PLANNING DEPARTMENT TRANSMITTAL TO THE MATOR'S OFFICE

CORRECTED LETTER OF DETERMINATION

Case No. CPC-2018-6693-GPA-SP-SPP

Project Site: Los Angeles Sports and Entertainment District (LASED)

**MAP 3
SUB AREAS**

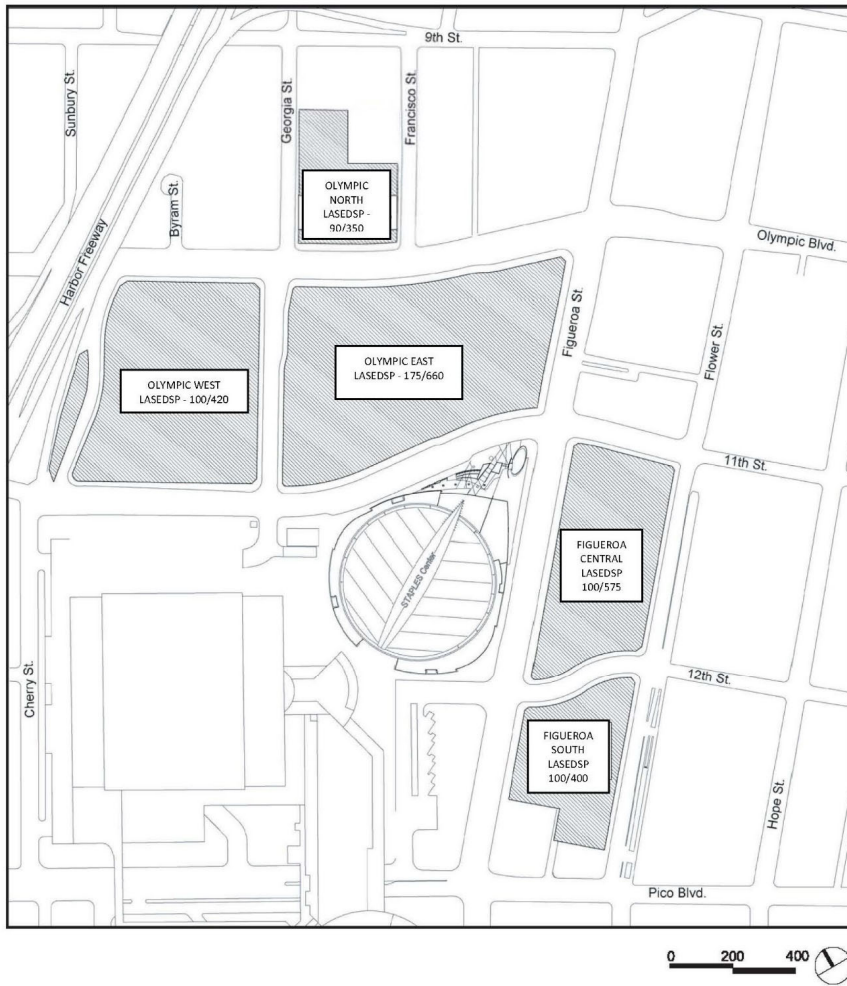
Commented [A2]: Map has been updated to reflect change in Olympic West height limit to 100/420 from 100/150.

EXHIBIT 1
ALLOWABLE BUILDING HEIGHT & MASSING OLYMPIC
WEST SUB-AREA

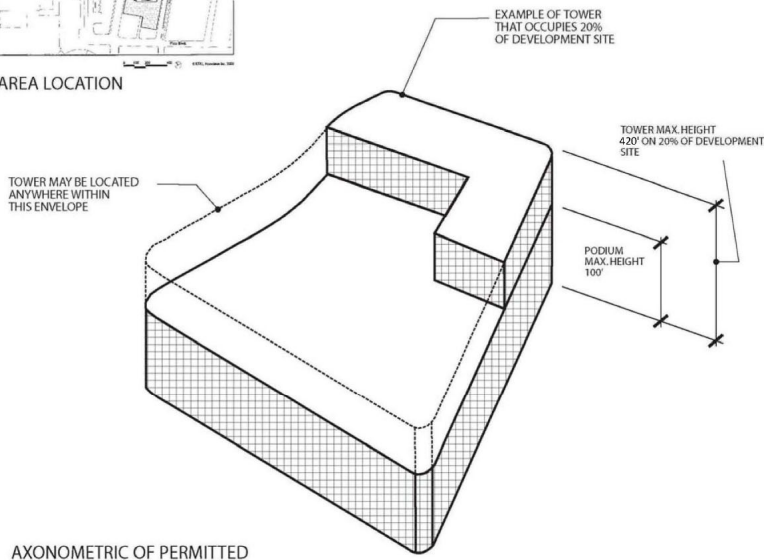
Commented [A3]: Exhibit has been updated to reflect a proposed change in the maximum tower height from 150 ft. to 420 ft.

MAP 7
FREEWAY EDGE SIGN LOCATIONS

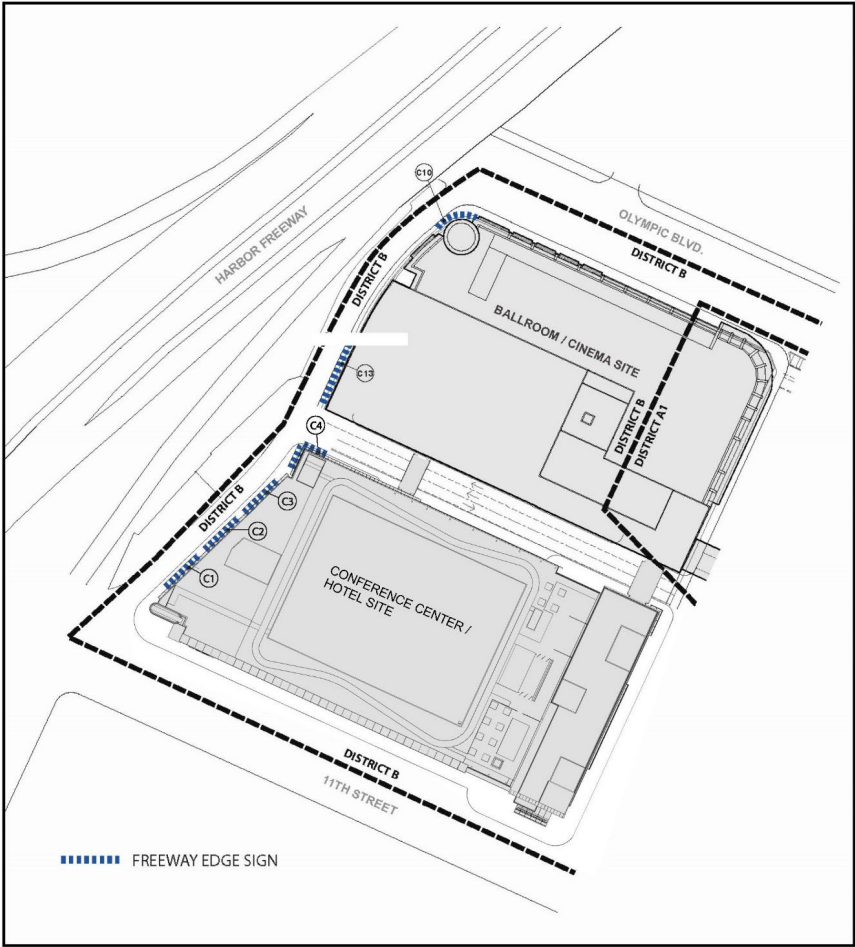
Commented [A5]: Map has been updated to depict the Conference Center/Hotel Site which was previously labeled as "Olympic West Parking Structure Site".

**MAP 8
SIGN DISTRICTS**

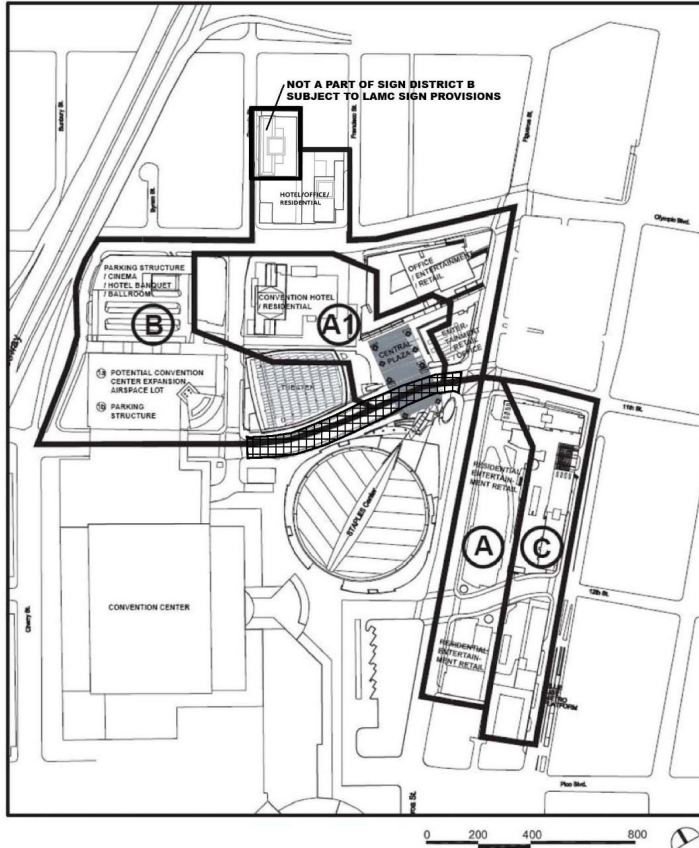
Commented [A6]: Map has been updated to show portion of Chick Hearn Court that shall be included within the boundaries of the LASED Specific Plan if vacated or closed to traffic.
